Subject: Contract No. 200-2004-03805, Task Order 3: The Review of NIOSH/ORAU Procedures and Methods Used for Dose Reconstruction

***REVIEW OF NIOSH/ORAUT PROCEDURES AND METHODS
USED FOR DOSE RECONSTRUCTION
Supplement 1***

Contract No. 200-2004-03805

Figure 3.7-1. K-S and A-D Statistics for All Distributions Fitted to a Sample of 10,000 Products using Crystal Ball 2000 Batch-Fit Procedure

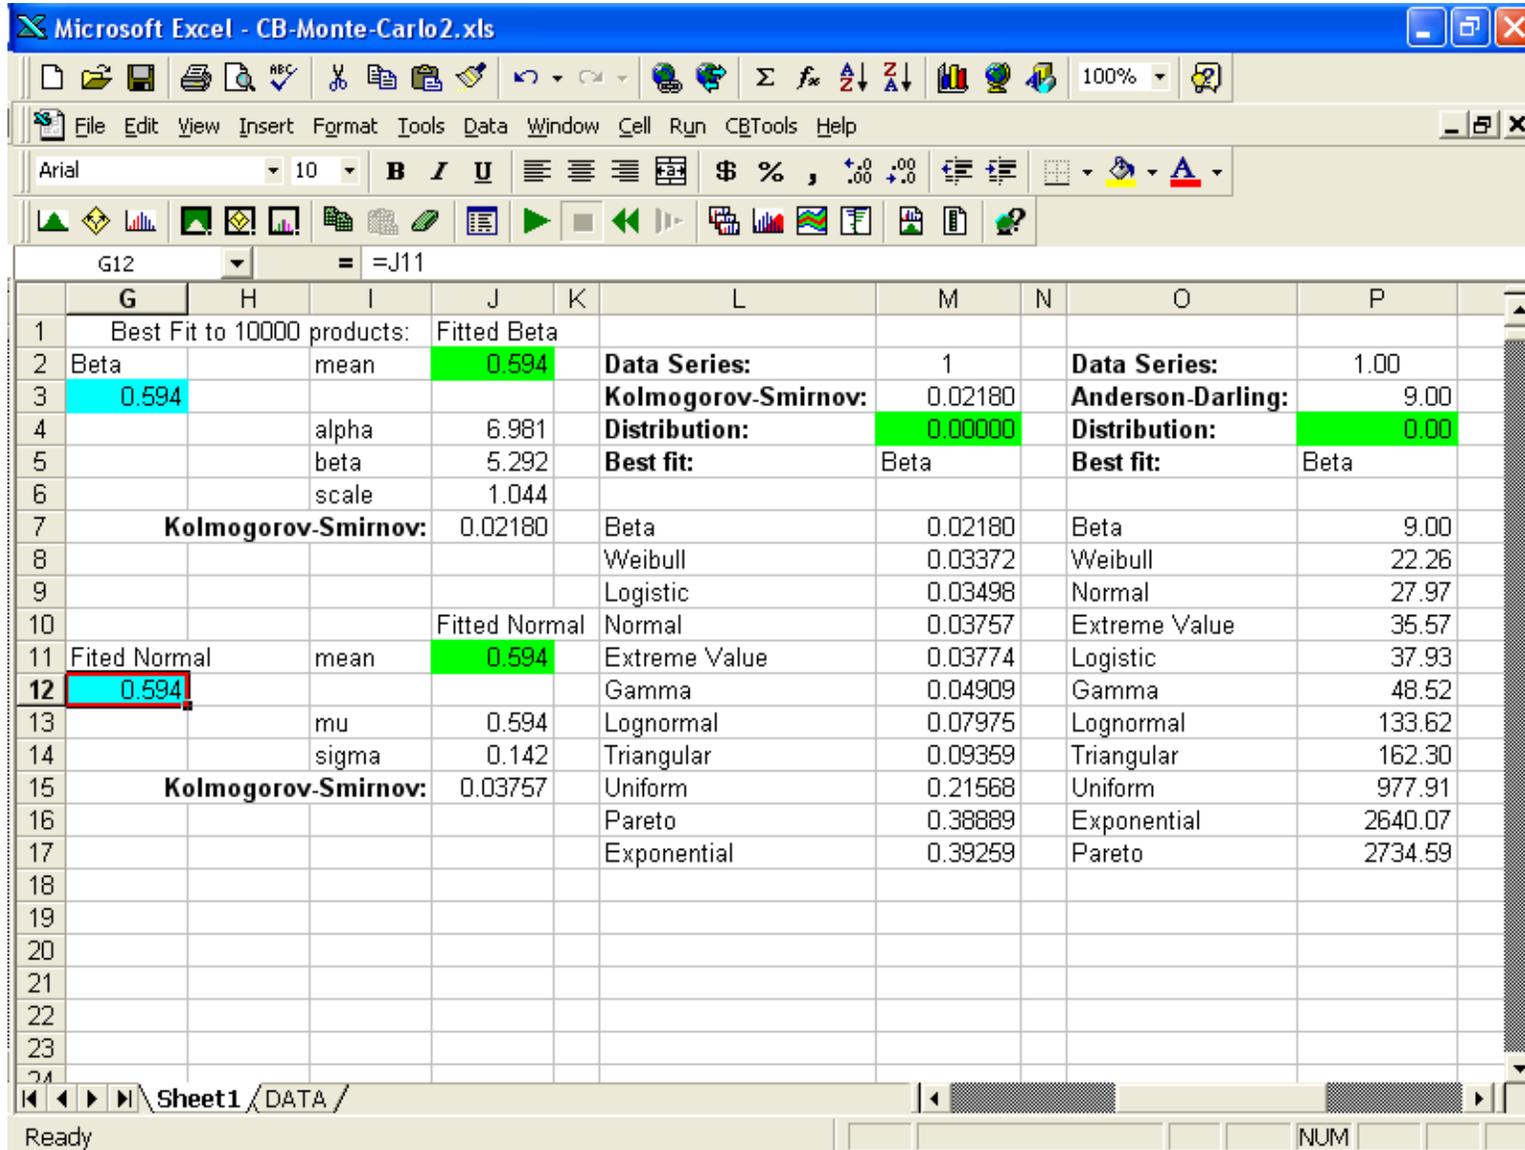
The results, shown in Figure 3.7-1, indicate that the beta distribution was found to be the best-fitting distribution under both criteria. In both cases, the second-best fit was obtained using a Weibull distribution. The normal distribution ranks third when using the A-D criterion, and fourth when using the K-S criterion.

Figure 3.7-2. The Best-Fitting Beta Distribution, Fitted to the Sample of 10,000 Products

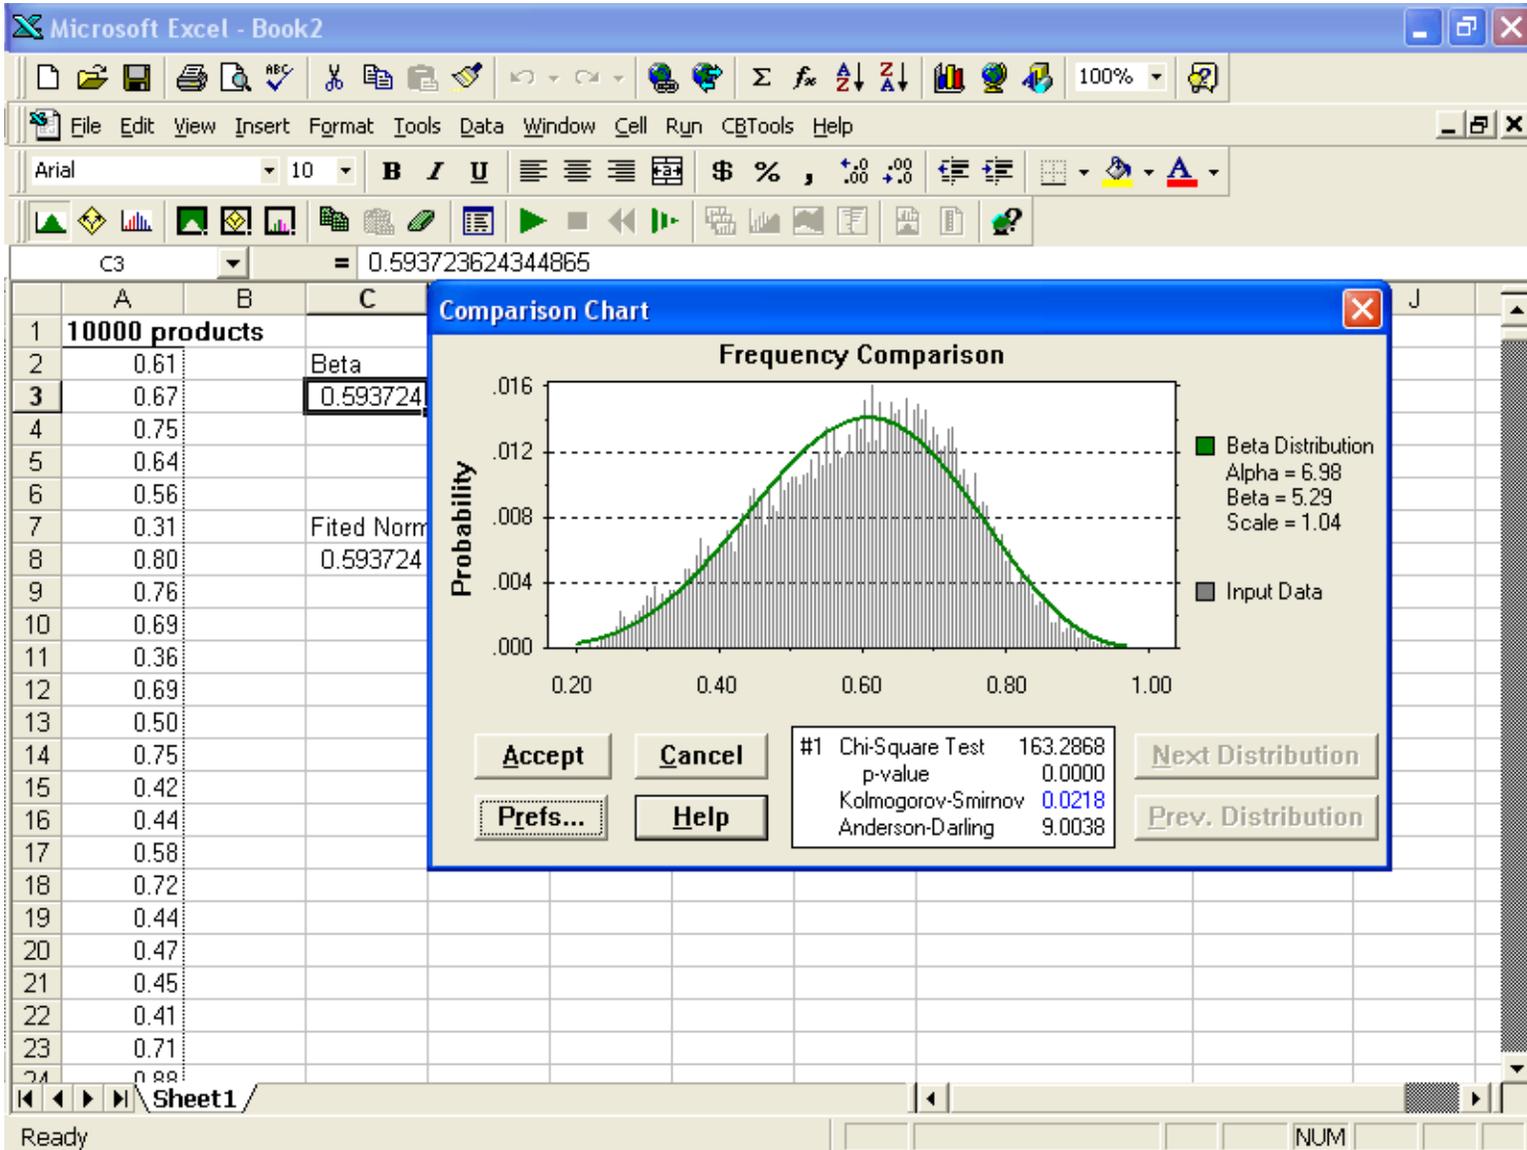
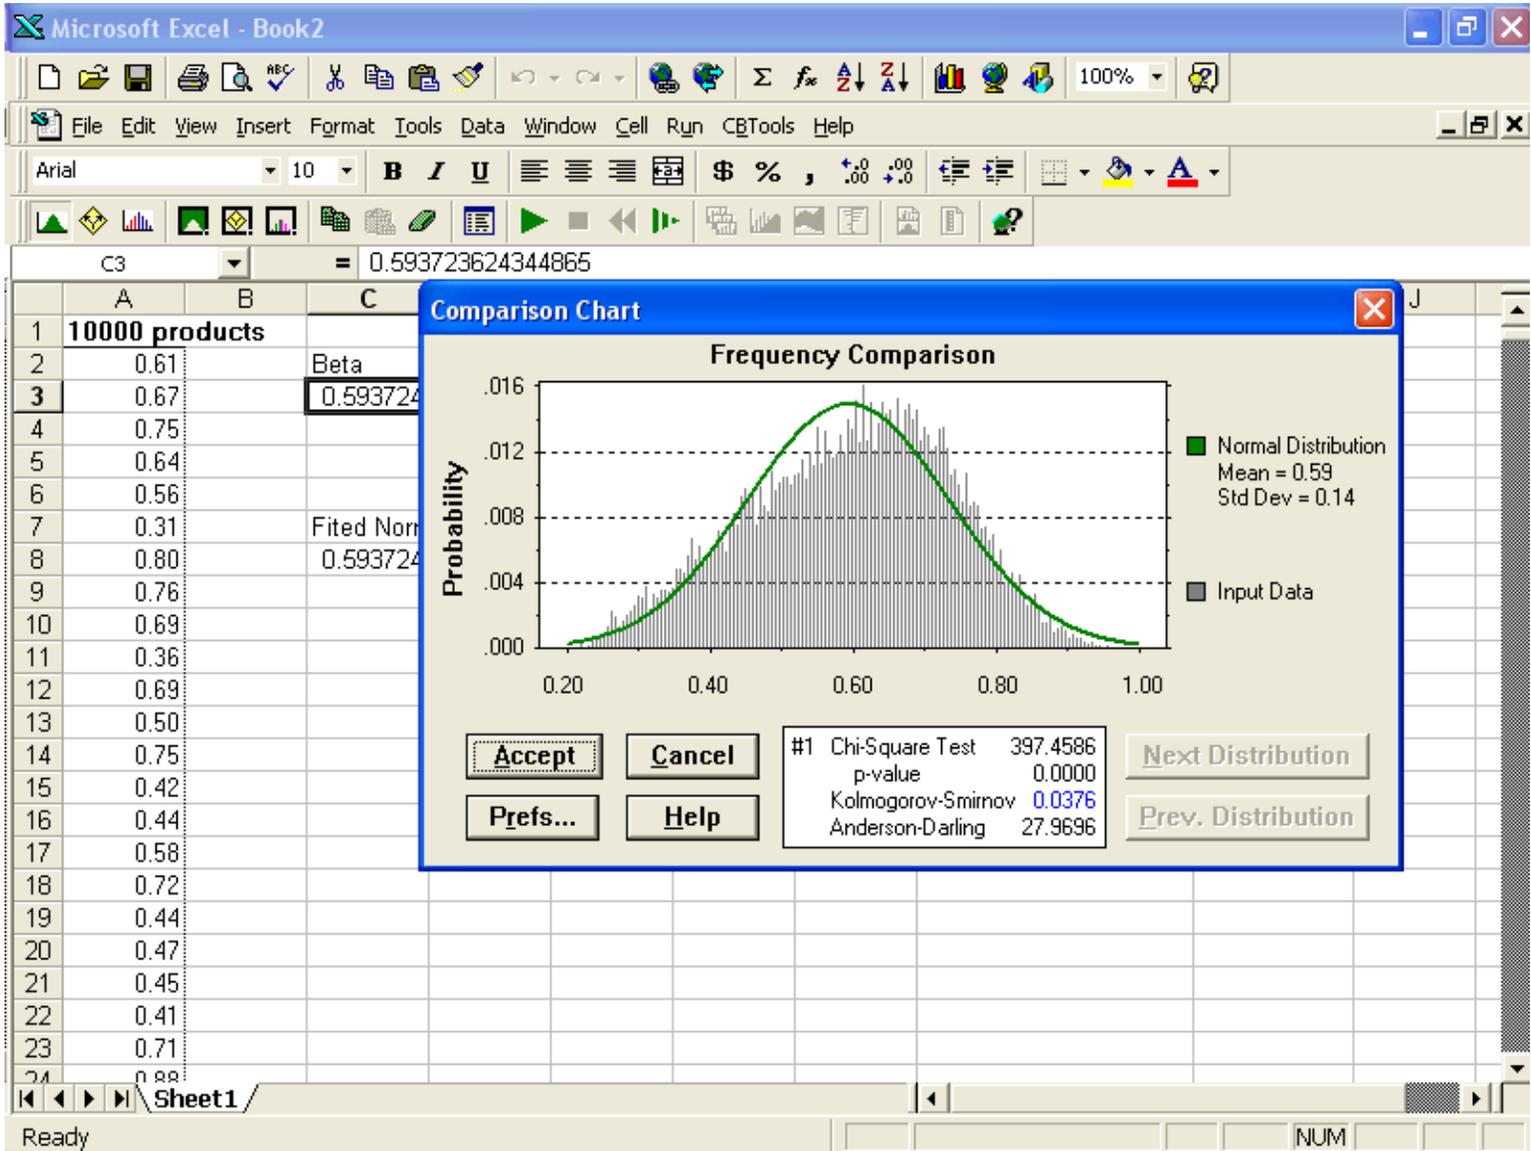
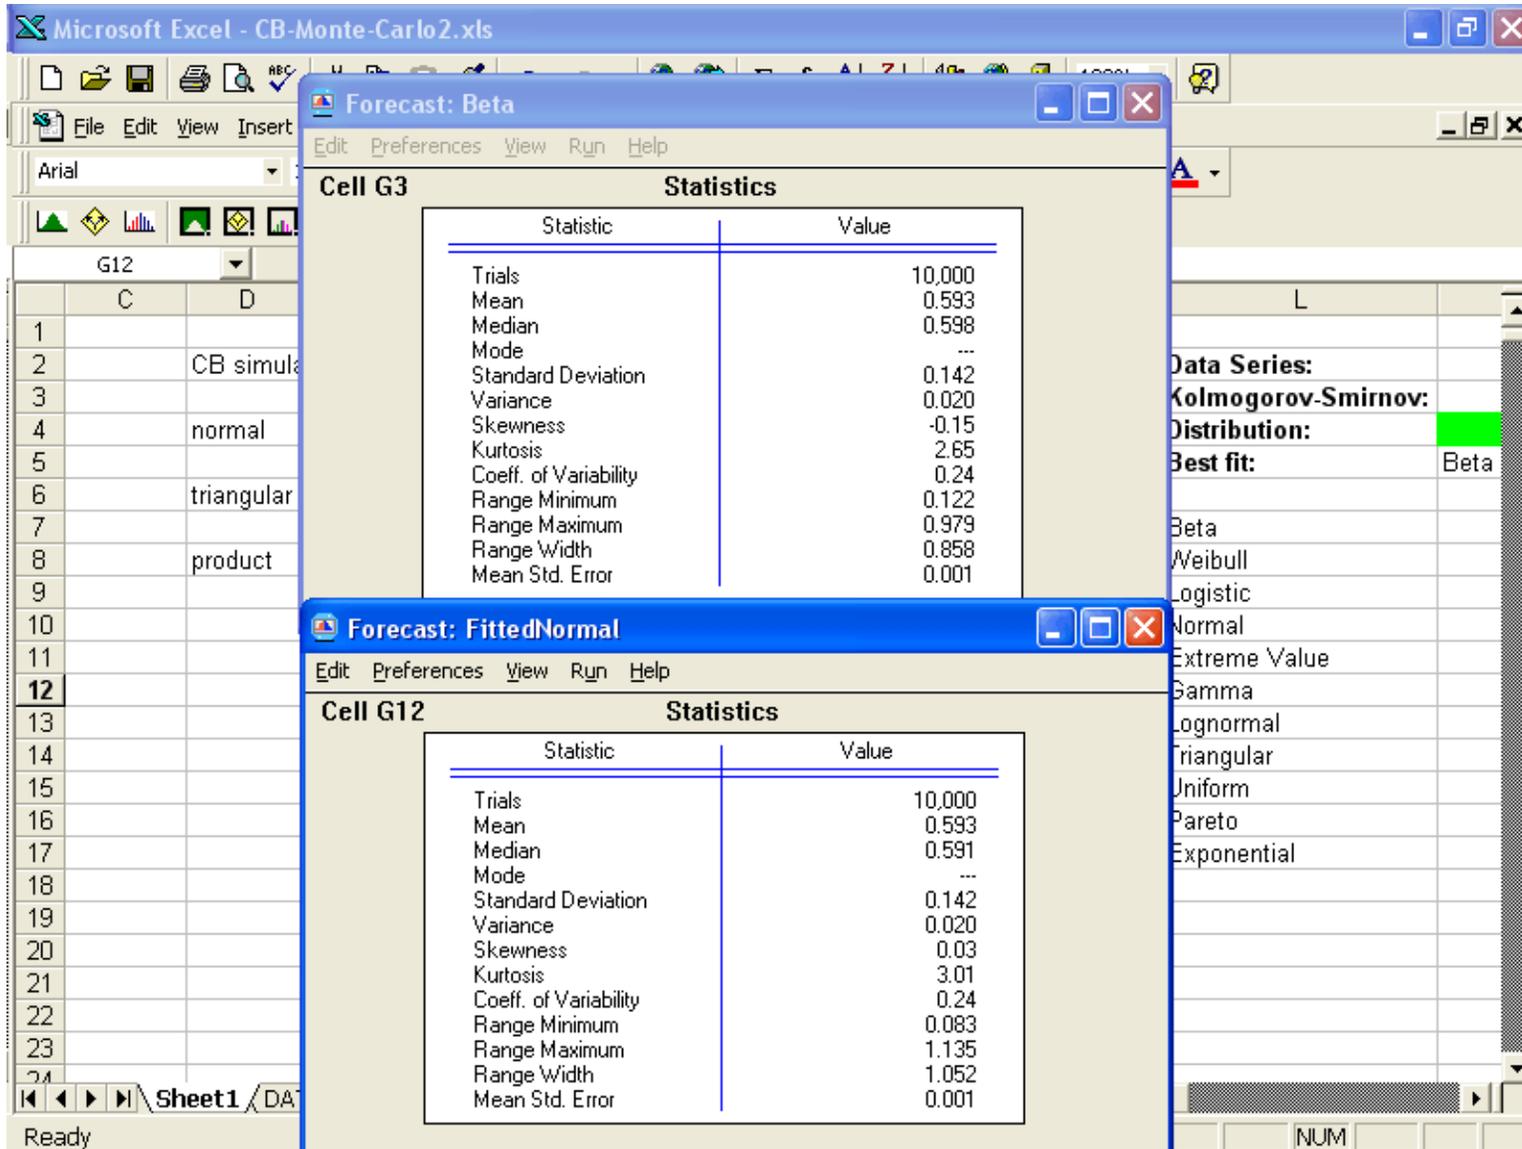
Two samples of size 10,000 were simulated in Crystal Ball 2000 using the fitted beta and normal distribution with parameters stated above. Despite the clearly better fit of the beta distribution based on the statistical tests, there is little difference in the statistics obtained from the two simulated data sets, as shown in Figure 3.7-4. This confirms that the best-fitting normal distribution provides a good approximation for the distribution of the product organ doses in the example selected. If the normal distributions for the dosimeter reading have a larger standard deviation than the 0.10 value in this example, it is likely that a normal distribution will continue to provide a good approximation to the distribution of the product's organ doses.
